**Zoning Ordinance Approval  
CITY OF AUSTIN**

**SUBJECT:** C814-90-0003.13 - Harris Branch PUD Amendment #13 - Approve second/third readings of an ordinance amending Chapter 25-2 of the Austin City Code by rezoning property locally known as 1375 U.S. Highway 290 East at Proposed State Highway 130 (Harris Branch, Gilleland Creek, Decker Creek Watersheds) from planned unit development (PUD) district zoning to planned unit development (PUD) district zoning to change a condition of zoning. First reading approved on October 27, 2005. Vote: 6-0, Council Member Alvarez off the dais. Applicant: Austin HB Residential Properties (John McCullough). Agent: Minter, Joseph & Thornhill, P.C. (John M. Joseph). City Staff: Sherri Sirwaitis, 974-3057.

## **ZONING CHANGE REVIEW SHEET**

**SHEET 2 OF 4**

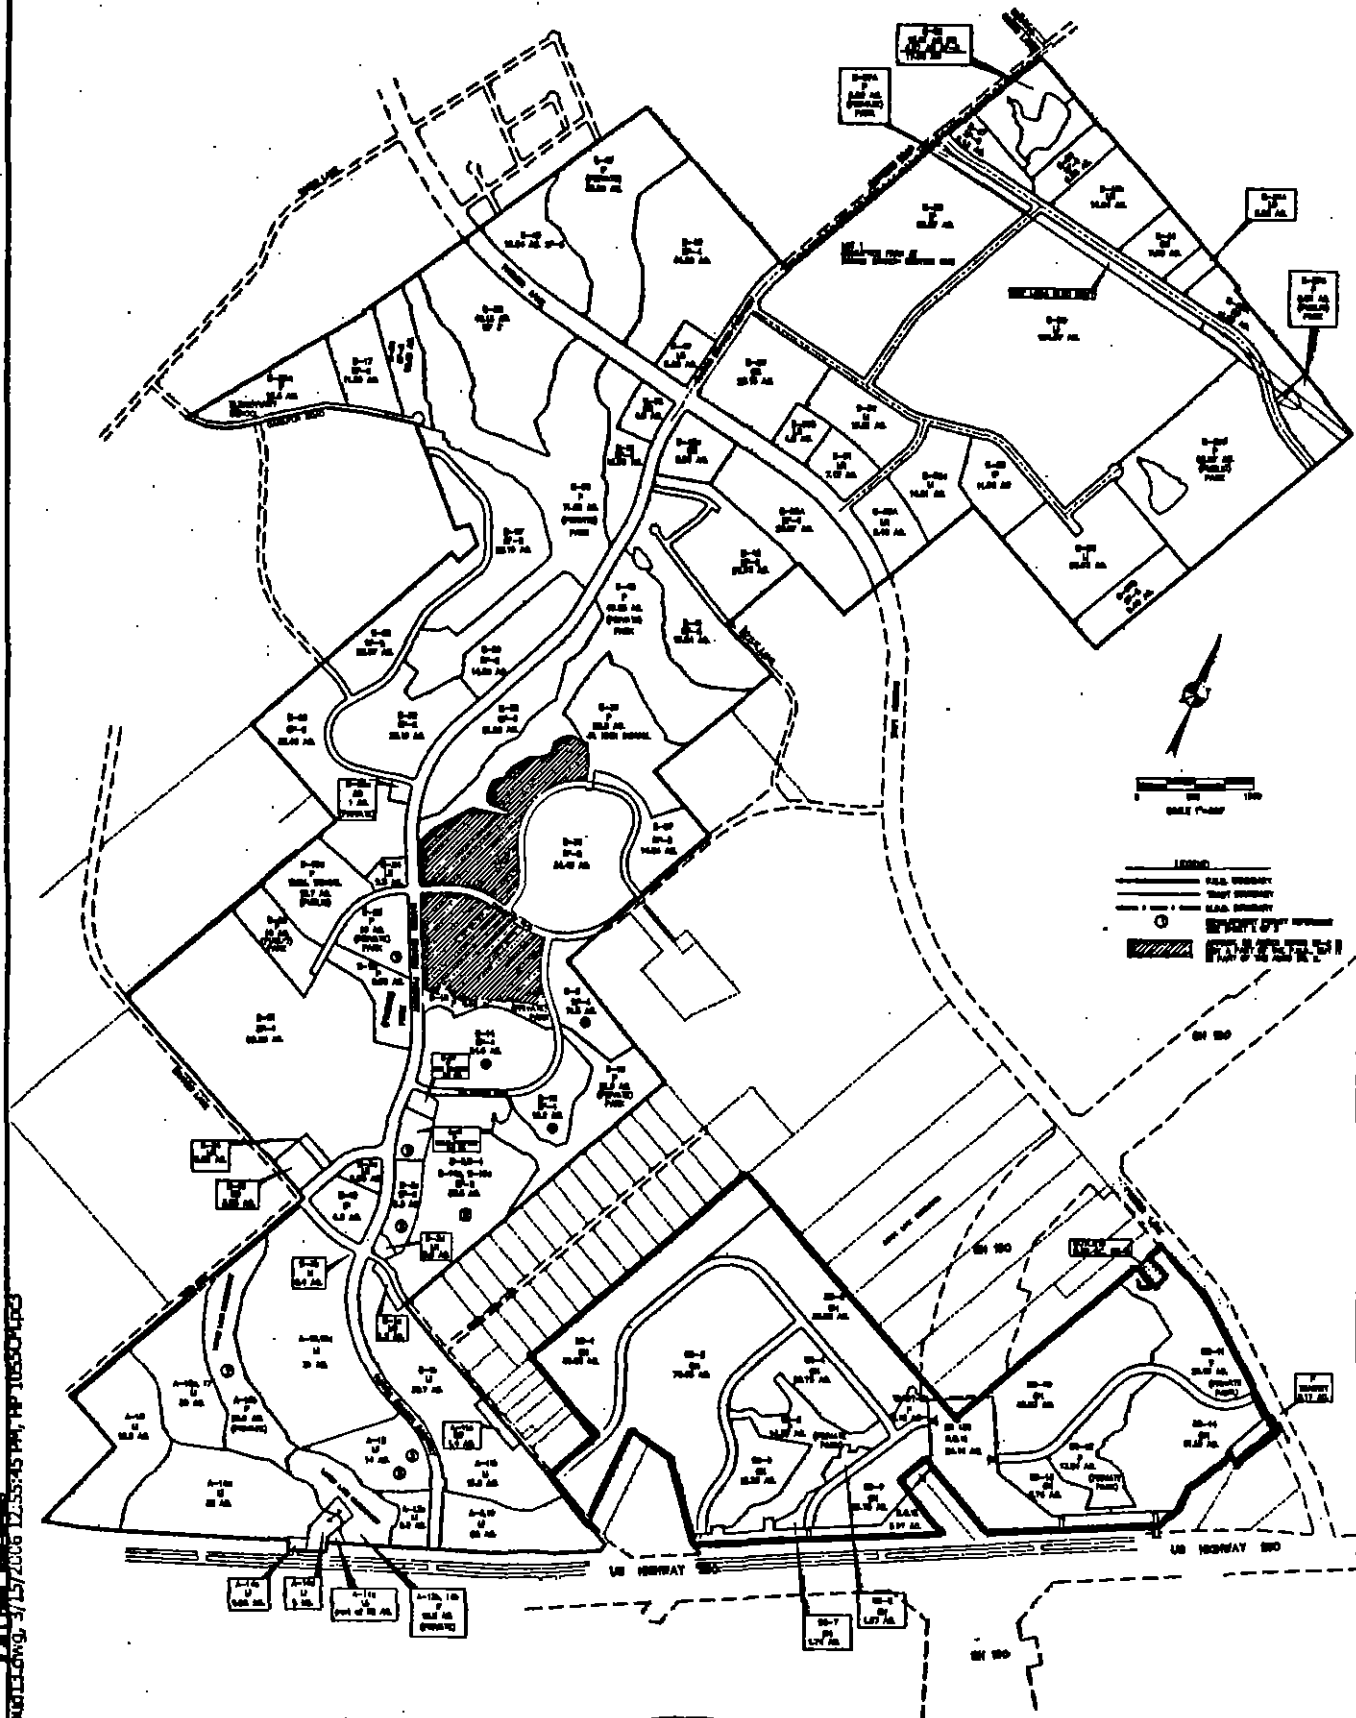
It is difficult to tell on sheet 2 of the PUD plan what has changed, since Revision 13 is with 11 & 12, and the changes were not clouded.

Please redline the approved Harris Branch PUD Land Use Plan to directly show the proposed changes for the PUD. Please redline the PUD Densities Tables - Sheet 2 to display how the proposed revisions to Tracts SG-1 through SG-14 will affect the breakdown of uses and within the PUD. Please provide information concerning the how the proposed land use changes will affect the overall building coverage and impervious cover amounts within the PUD.

**ZN-2 The Harris Branch PUD Land Use Plan has a "red line" drawn around the areas subject to this amendment. Attached Please see the revised Harris Branch Density Tables – Sheet 2 showing the effect on building coverage and impervious cover.**
